**CITY OF NOVI CITY COUNCIL
DECEMBER 19, 2022**

SUBJECT: Final approval of the request of Cambridge of Novi, LLC for a Second Amendment to the previously approved Planned Rezoning Overlay (PRO) Agreement, JSP 17-52 and JSP 21-12, Terra, associated with Zoning Map Amendment 18.718. The applicant received approval for a 41-unit single-family ranch development on approximately 30.14 acres on the north side of Nine Mile Road, east of Napier Road. The current amendment is requested to make changes to sidewalks in the Phase 2 portion of the project and clarify woodland tree replacement planting.

Planning Review

2nd Amendment to the PRO Plan & Agreement (JSP17-52) and 2nd Revised Final Site Plan (JSP21-12)

Figure 1: PRO Agreement, Exhibit B, Sheet 4, Liber 52674 Page 562

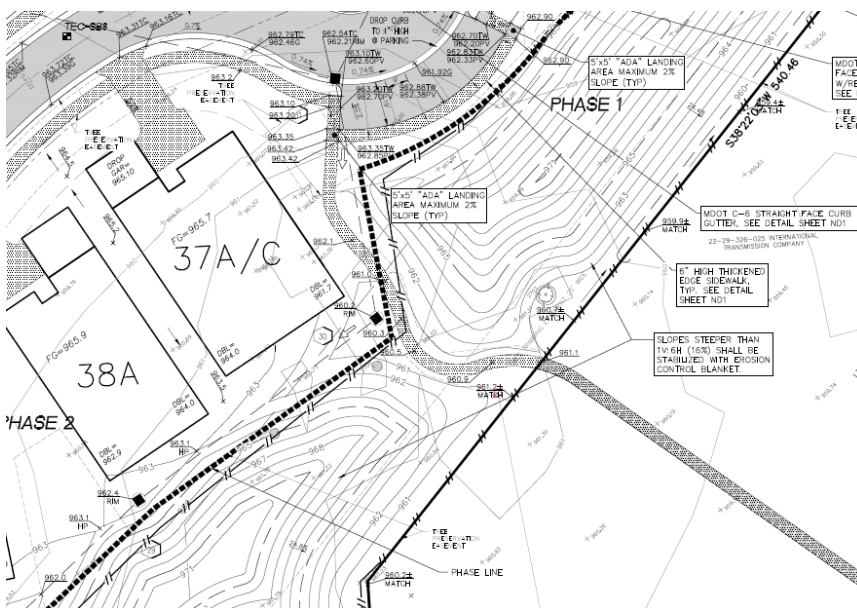
1. Sidewalk Connection to ITC Corridor: The PRO Agreement states on Page 4, Item 6: "The applicant will work with staff to identify a proper location to connect to ITC trail, beyond the subject property line." The 5-foot wide asphalt sidewalk is shown on the PRO Plan in Exhibit B of the Agreement, and in the Phase 2 site plan. The applicant states the residents of the development would like to eliminate the sidewalk connection in order to continue the berm to provide additional screening of the ITC transmission towers, as well as to limit pedestrian traffic into the community. They have provided letters from several current and future residents that echo support for eliminating the connection. They also point out that the sidewalk at the main entrance provides a connection to the ITC Trail.

While the connection to the ITC Trail is not a requirement of the Zoning Ordinance, its inclusion in the original PRO Plan and Agreement appeared to be presented as an amenity to the community. However, it was not specifically mentioned as a “public benefit” per say or stated as a requirement. Staff prefers the segment be provided in the interest of enhancing non-motorized connectivity throughout the community.

Figure 4: Original sidewalk plan, June 2021

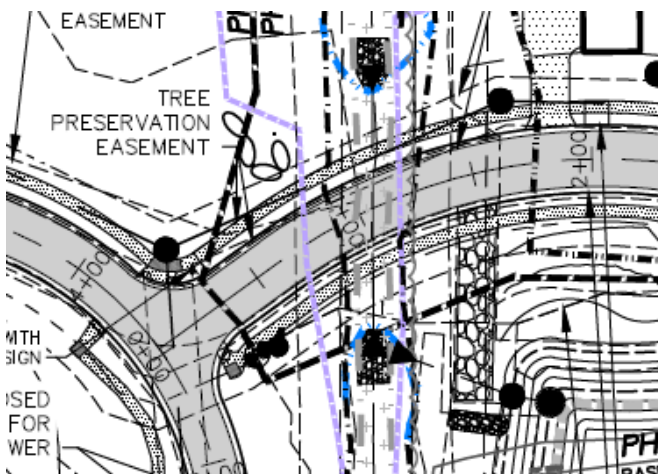
2. Sidewalk on Villa Court: The Subdivision Ordinance (Section 4.05) and the Design & Construction Standards (Section 11-256(b)) both state that sidewalks shall be provided on both sides of proposed drives. The applicant received a deviation in the original PRO Agreement to not provide a sidewalk on the east side of the main entrance drive (Villa Drive) due to the presence of wetlands, with a payment to the sidewalk fund required in lieu of building it. The applicant now requests a deviation to remove a portion of the sidewalk on the south side of Villa Court. During construction of the culvert for the Garfield Drain, the decision was made by on-site engineers to shift it to the north a few feet to avoid eroding soils over time. This change created a narrower space between the road and the slope to the culvert to place the sidewalk as shown on the original plan. Staff was made aware of the change and encouraged the applicant to work with their engineers to try to fit the sidewalk by moving it closer to the road or by building a retaining wall. The current plan shows the sidewalk ending on the south side of Villa Court about 110 feet east of the intersection with Villa Drive, with ramps provided to enable pedestrians to cross the street to connect to the north side sidewalk. No crosswalk markings are proposed. **Staff recommends the applicant adhere to the Code to provide the required sidewalk. Based on the plan it still appears feasible to fit it between the road and the culvert.**

- a. Engineering Review: **Engineering does not recommend approval of the deviation required for the missing sidewalk segment on Villa Court.**
- b. Landscape Review: **Landscaping does not recommend approval to allow the applicant to pay into the tree fund as it appears there are other locations on-site to plant them on site.**

Figure 6: Phase 2 Landscape Plan, June 2022

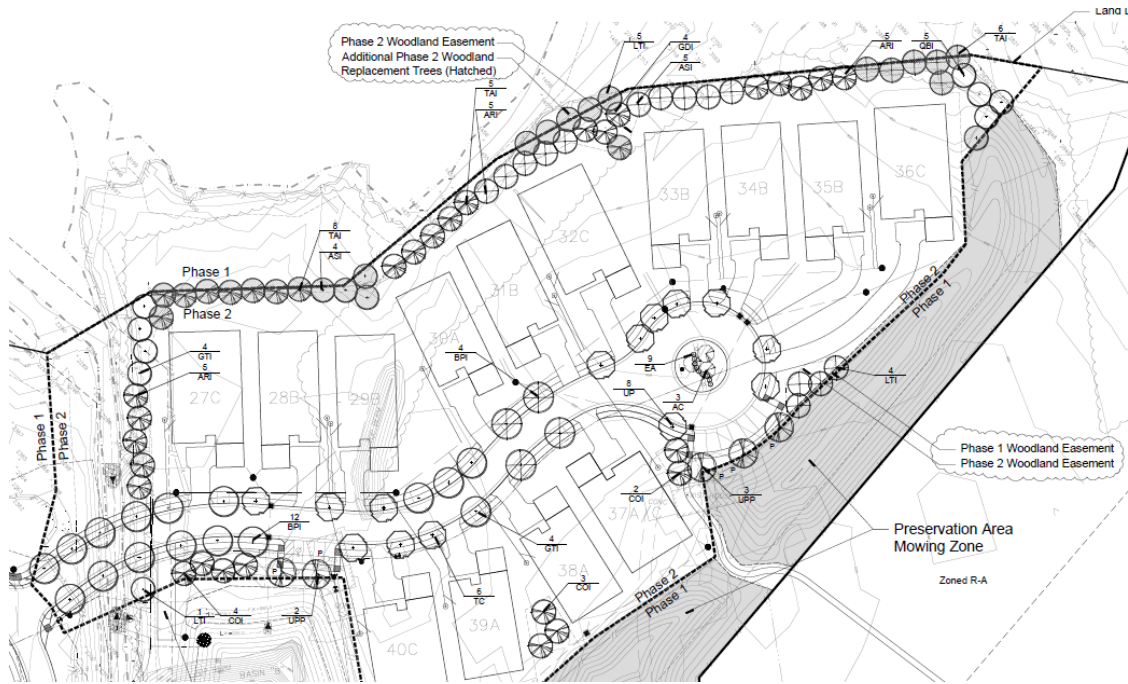
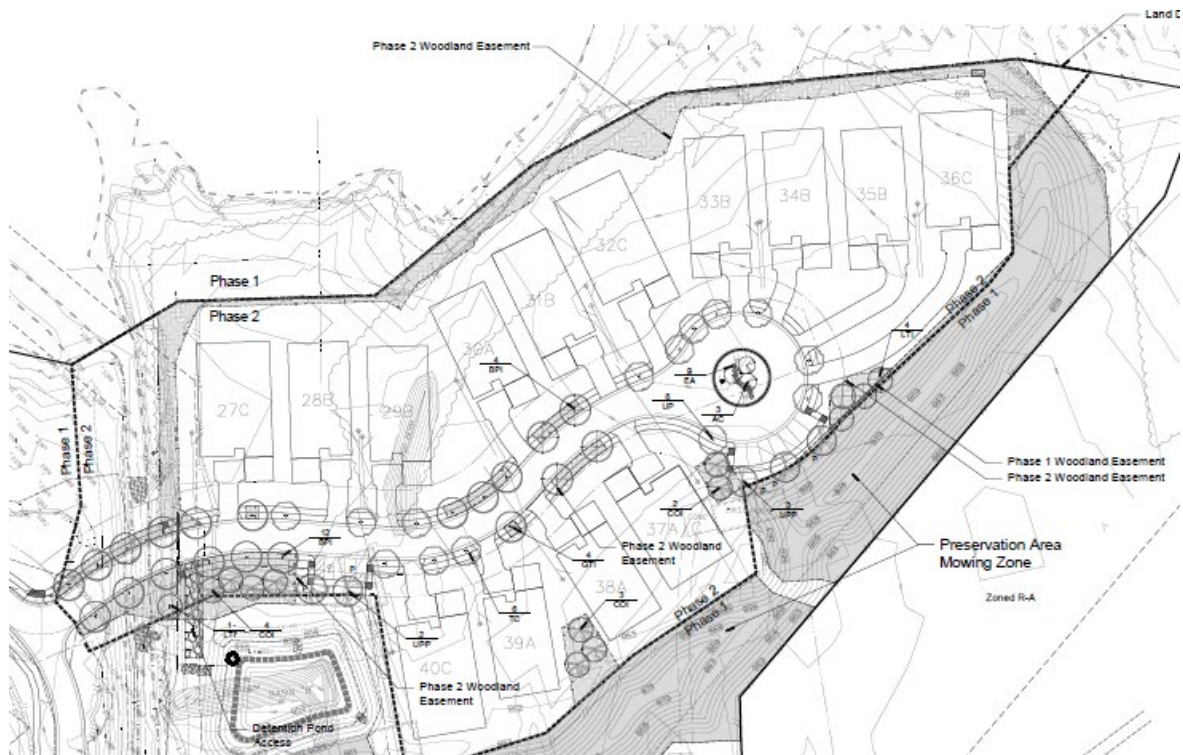
3. **Woodland Trees:** When the Phase 2 site plan was approved the applicant had shown 51 woodland replacement trees to be planted beside and behind units 27-36. The applicant would instead like to pay into the Tree Fund rather than planting the replacements on the site. The applicant states the proposed trees were going to be too close to the homes. **While the Woodland Ordinance permits applicants the option to pay into the Tree Fund, the Woodland Permit from the Planning Commission was approved with the understanding that the credits would be planted on-site. It also appears there would be additional locations on the property where woodland trees could be planted, as noted in the Landscape Review.**

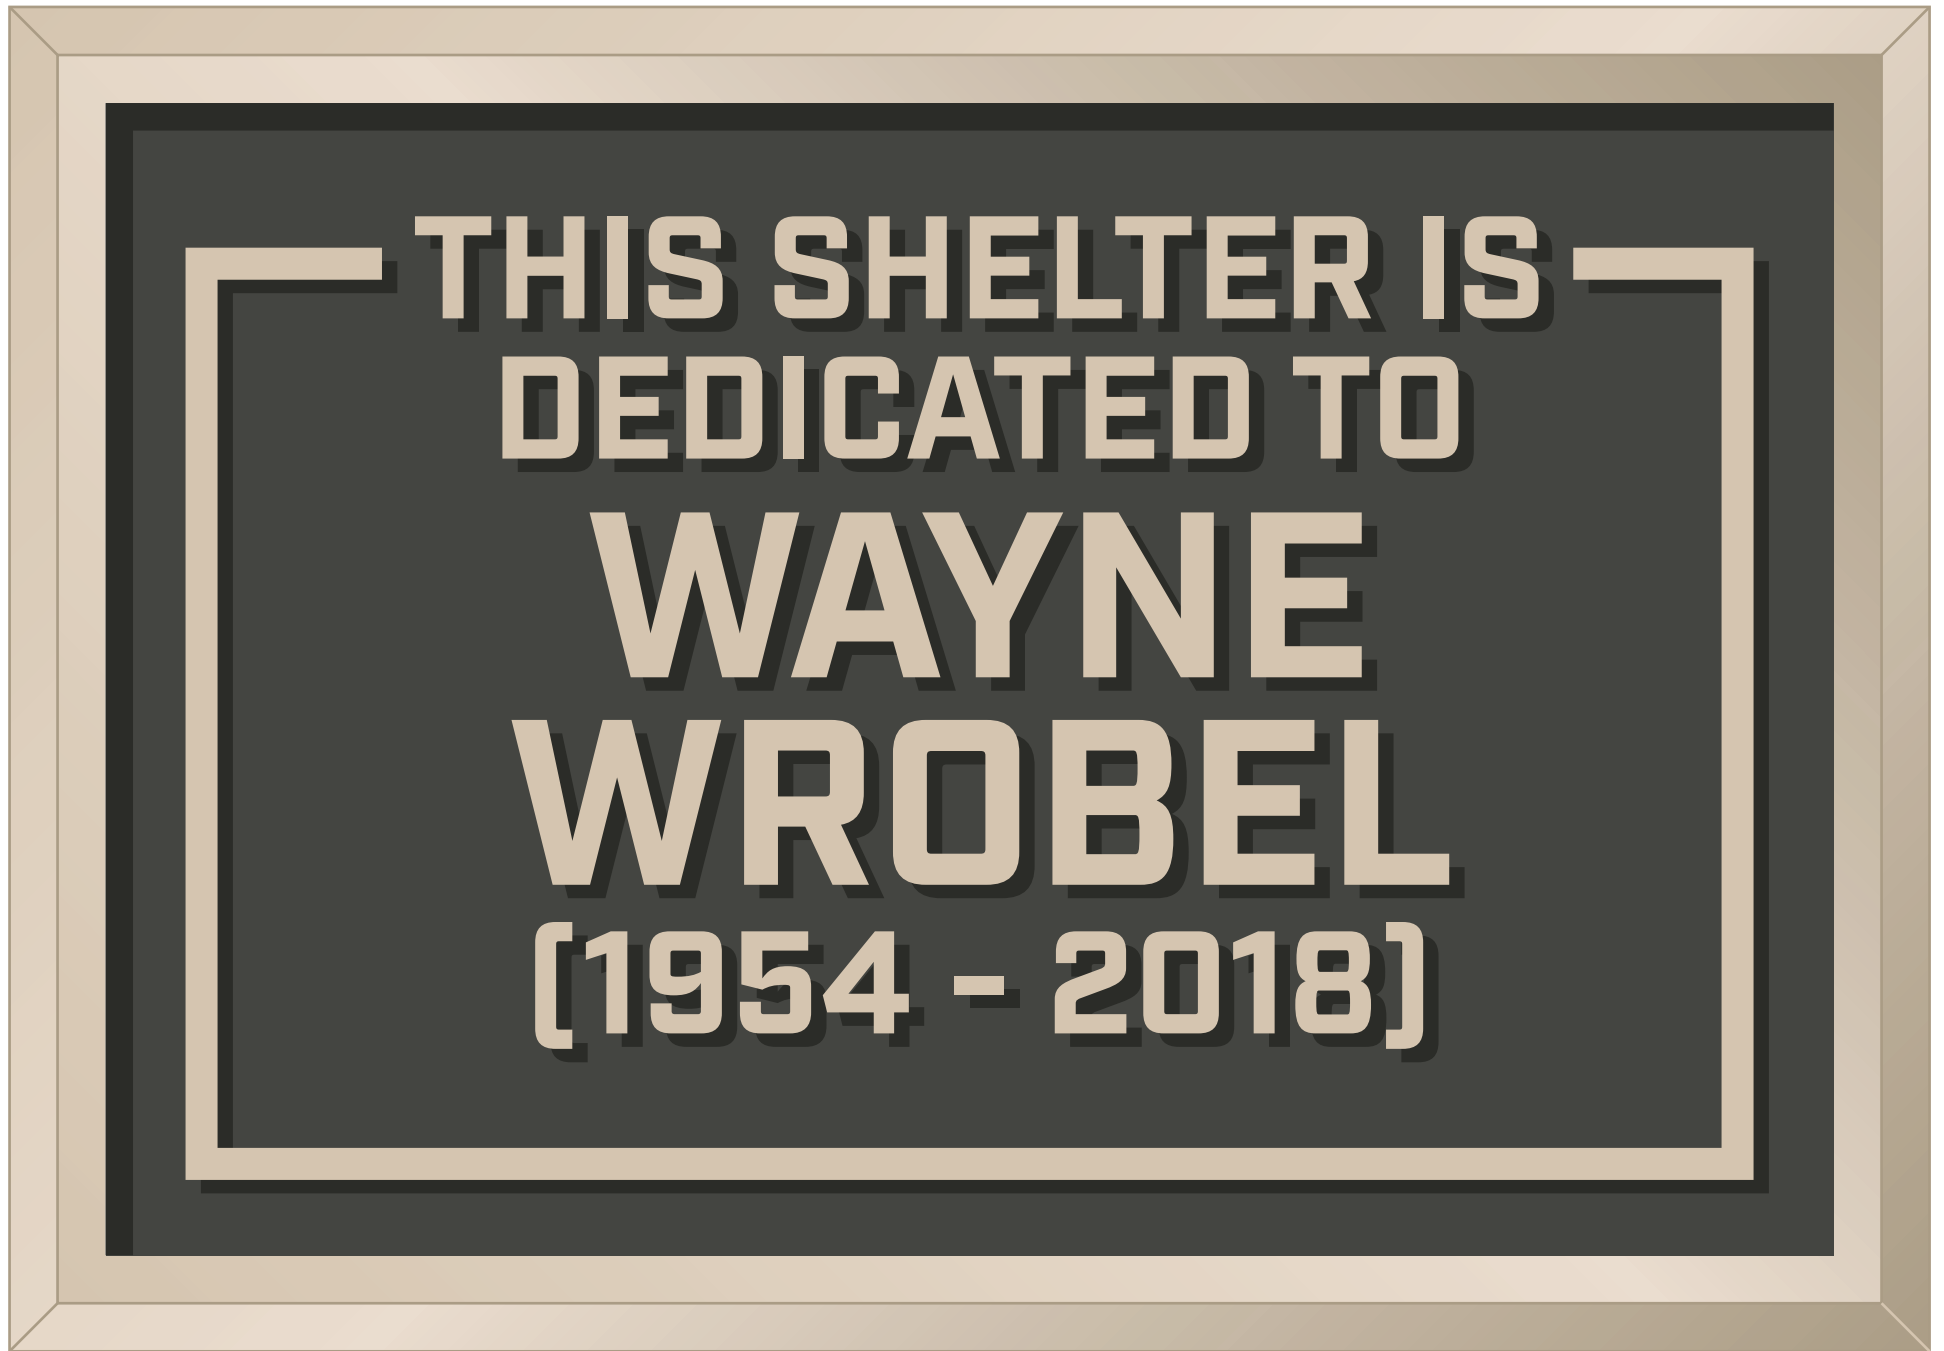
3. We will work with Rick Meader to relocate the 51 woodland replacement trees behind lots 27-36 in phase 2 and move them to a new location in Terra.
4. To honor the memory of Wayne Wrobel, we are proposing to dedicate the ITC Comfort Station in his name by adding a bronze plaque with his name and a few words attached to the new comfort station off of Nine Mile Road. See the attached rendering for review.
